13<sup>th</sup> July 2023 Hygge Property Attention: Adam Davidson, Project Manager

# Re: Response to email, Subject: 9 Raglan Street - Avenue of Honour Tree

Figure 1, Direct extract from the Preliminary Arboriculture Tree Assessment Report for Raglan and Smith Street Daylesford, issued on the 19<sup>th</sup> November 2022 Tree ID:2 located at the entrance of the property

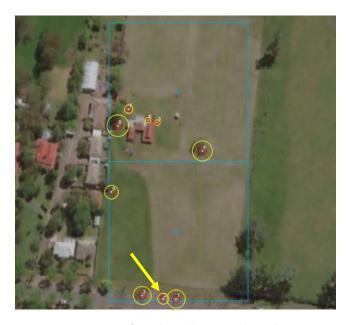
Confirmation regarding the location and ID number of the proposed Avenue of Honour tree that is required to be retained by Condition 1b) and removed by Condition 88. Our assessment of the arborist report prepared by Xylem Tree Care indicates that the tree is Tree ID:1, which is a mature Desert Ash in good health with fair structure. Please confirm if this is correct.

According to the Xylem TreeCare – Preliminary Arboriculture Tree Assessment Report for Raglan and Smith Street Daylesford, issued on the 19<sup>th</sup> November 2022 (PATA) the tree is Tree ID:2 not Tree ID:1 as outlined above. This tree is located at the front entrance of the property. The subject tree is Fraxinus angustifolia subsp. angustifolia (Desert Ash) and at the time of assessment the tree received a health rating of 'Good' and structure rating of 'Fair'.
